QUESTIONS ON WATERFORD 3 BASEMAT
3/26 MEETING IN BETHESDA

Allegations recently reported in a GAMBIT newspaper article and in staff investigations concerning the GAMBIT article have lead to the assignment of additional reviewers to evaluate the base mat adequacy. This transmittal is a composite set of Questions from the reviewers, and is intended to faciliate LP&L's preparation for the meeting on March 26, 1984 in Bethesda.

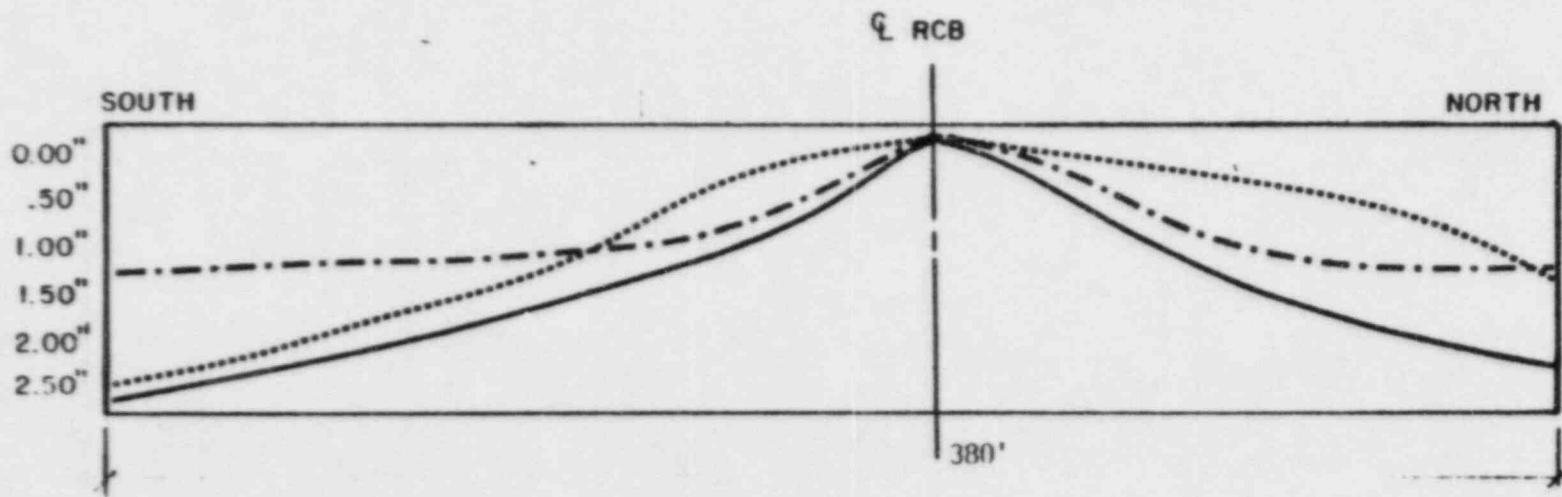
3. Is there any evidence of convex curvature due to ring wall loading?

↑ this should help flexure argument.

Attached is a graph (Figure ES-3) reflecting the contours obtained from the maps generated on April 22, 1977, November 10, 1977, and October 9, 1979. These curves reflect a before mat (ring wall) loading, after ring wall placement and a majority of concrete construction complete. These contours do reflect a convex mat with maximum differential of two inches (2").

AMENDMENT NO. 22 1949
LOUISIANA POWER & LIGHT CO.
 Weirford Steam Electric Station
 PREDOMETER, HEAVE POINT AND
 EXTENSOMETER RESPONSES
 SHEET 1 OF 8
 FIGURE 25 113

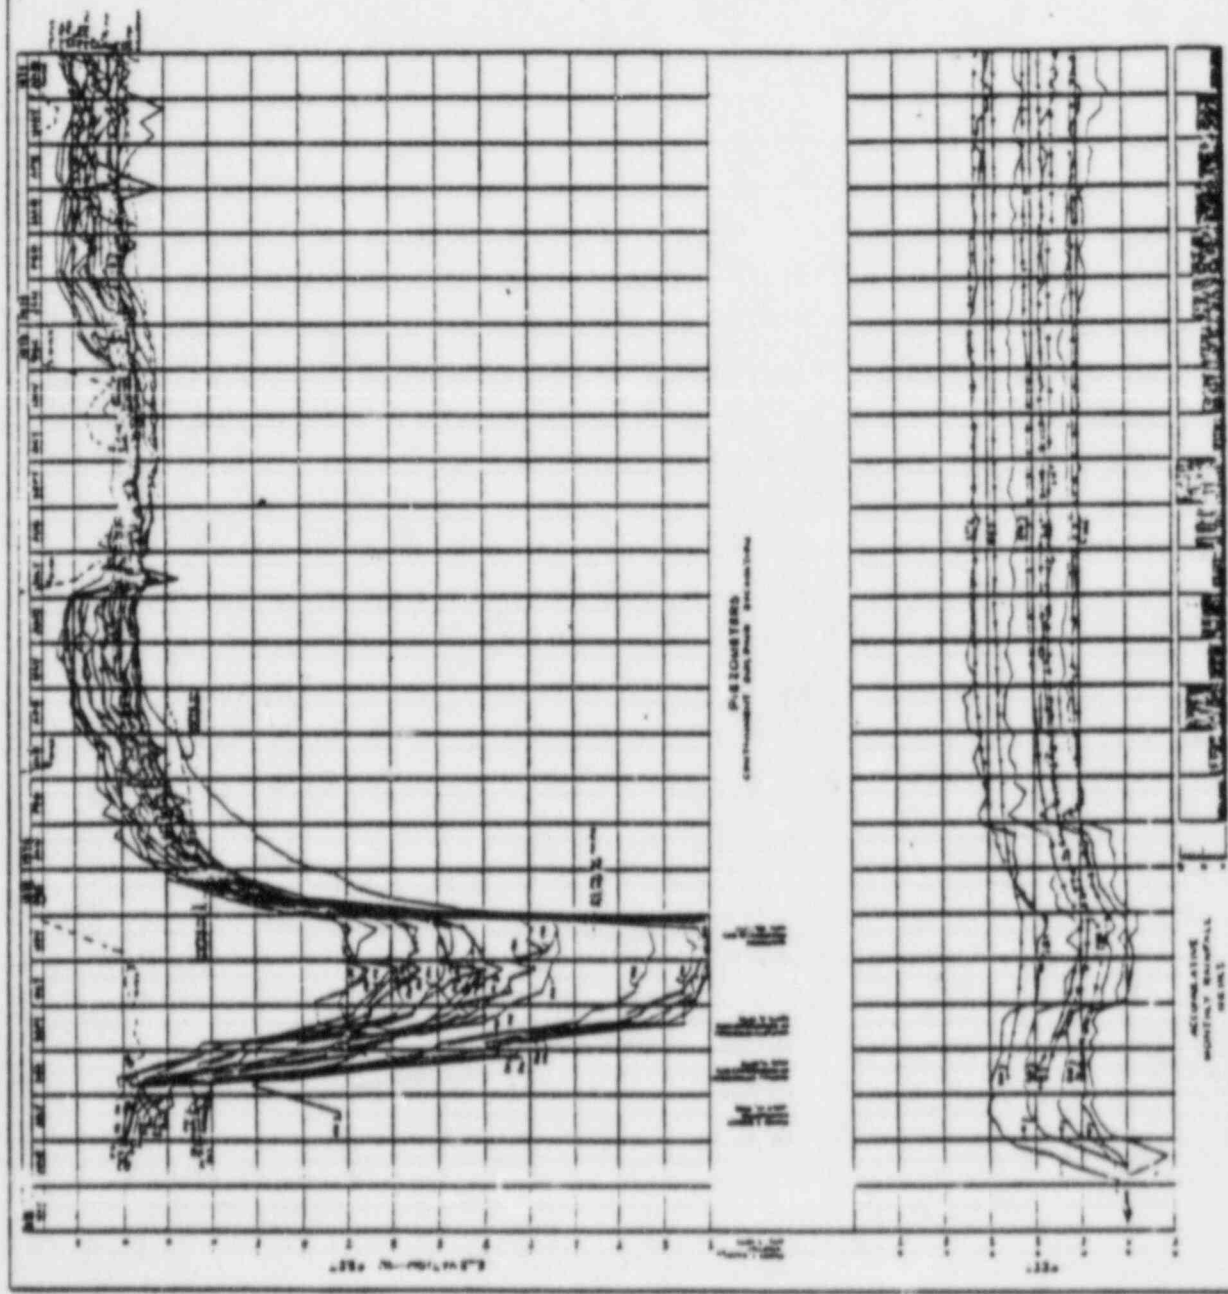
5. a) Provide complete documentation of groundwater control and foundation heave from the start of dewatering until the present time. b) Include the history of soil excavation and backfill beneath the mat.

Groundwater control and foundation heave from the start of dewatering until recent time are exhibited in FSAR Fig. 2.5-113 (sheets 1/5 to 5/5).

AMENDMENT NO. 34 11-80
LOUISIANA POWER & LIGHT CO.
 Waterford Steam Electric Station
 COMPOSITE FOUNDATION MAT
 SETTLEMENT
 SHEET 1 OF 3
 FIGURE 2-B-117

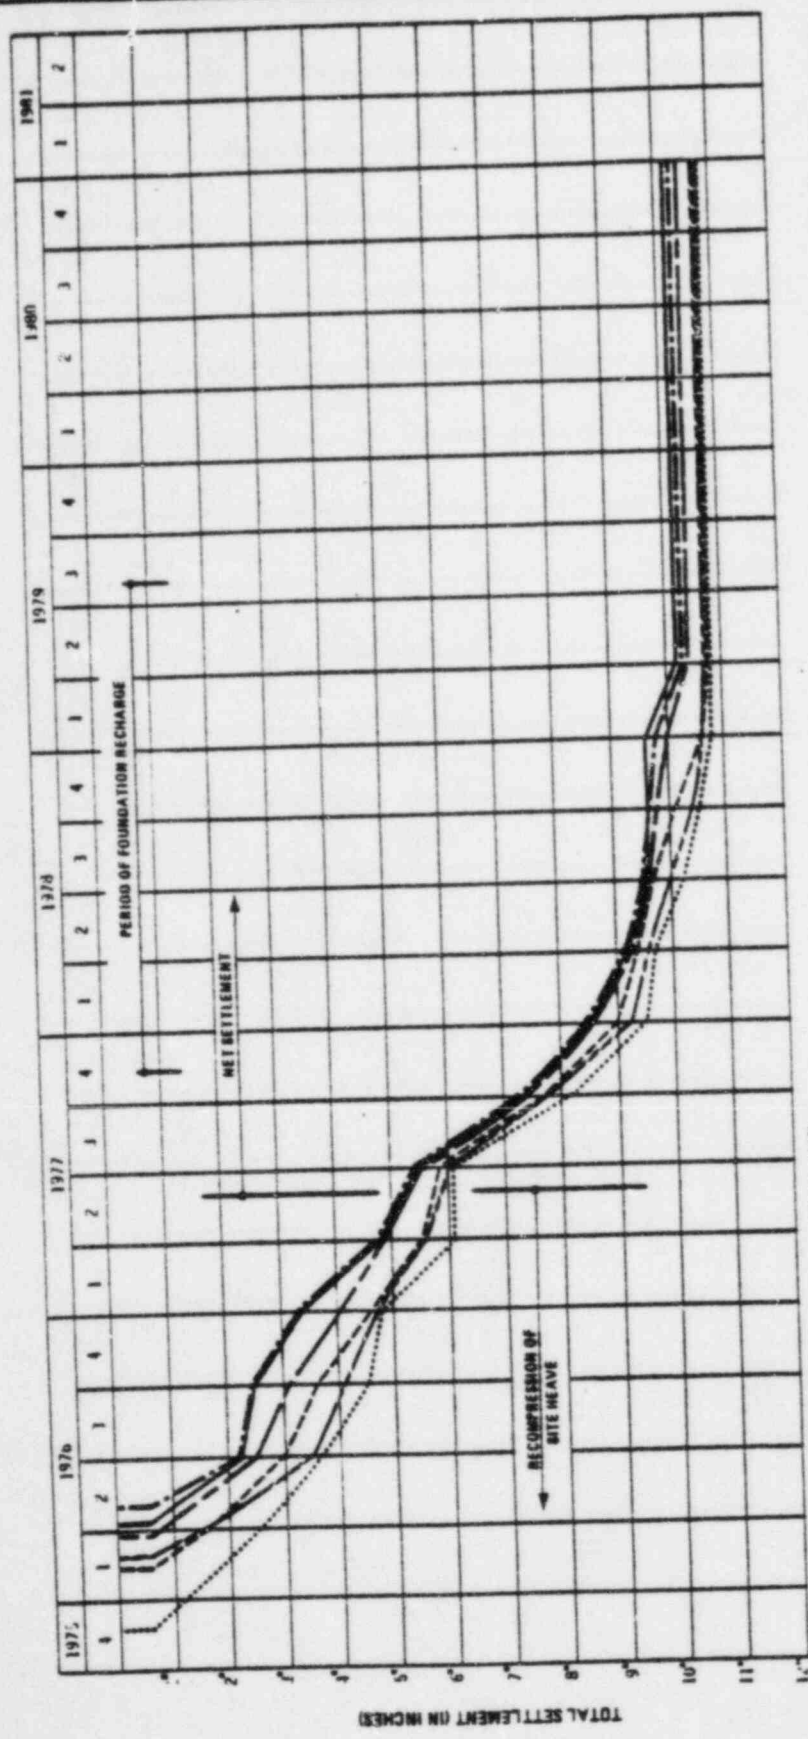
6. Provide the foundation loading history under each block during construction of the mat and walls. This should include the distribution of pressure under each block. Include the location and history of loads due to backfilling adjacent to foundation blocks.

A computer program was developed and maintained weekly to monitor the placements made. Accumulative soil stresses were identified and maximum/minimum total stresses were noted. These figures and the differential stresses were reviewed. Differential stress did not exceed the maximum allowable of 1.0 KSF. *define*

As can be noted on the Composite Foundation Mat Settlement (Figure 2.5-117 in the FSAR), recharging of the water table began in late 1977 and was gradually charged until completion in late 1979. Recharging commenced based on total stresses achieving the 4.5 KSF criteria. The initiation of recharging the mat was approximately week no. 85 of construction.

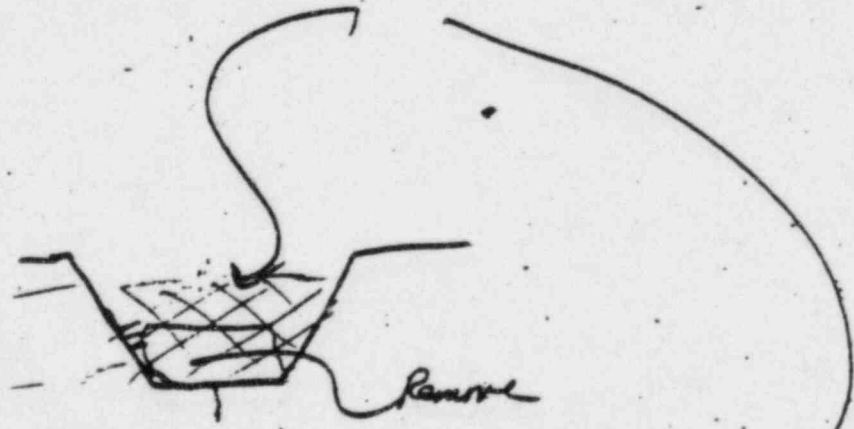
The top of the mat beneath the containment structure contains a number of cracks which were discovered to be weeping water. The rate of weeping is generally enough to show the crack and to moisten the surrounding concrete. It appears that these radial cracks are the result of the concave shape which the material has assumed due to differential settlement.

After an unsuccessfull attempt at pressure injecting epoxy grout into the cracks, the following procedure should be used to effectively control the leakage or weeping of water through the cracks.

- 1 - Chip a 1" deep trench along the length of the crack.
- 2 - Roughen (by sandblasting or bush hammer) and clean the surface thoroughly along the crack as well as a 1 ft. strip on either side of the crack.
- 3 - Fill the 1" deep trench with SIKA Hi-Mod-LV epoxy which may be used as a seal coat in the dry, damp or wet area in accordance with manufacturer instructions and surface preparation.
- 4 - After the epoxy is tack free, apply a brush coat of the Hi-Mod-LV to the roughened and clean surface 2 ft. wide along the crack length.
- 5 - Monitor the repairs for 1 day to visually inspect that leakage has ceased to penetrate the cracks. At this time, the concrete placements may continue.
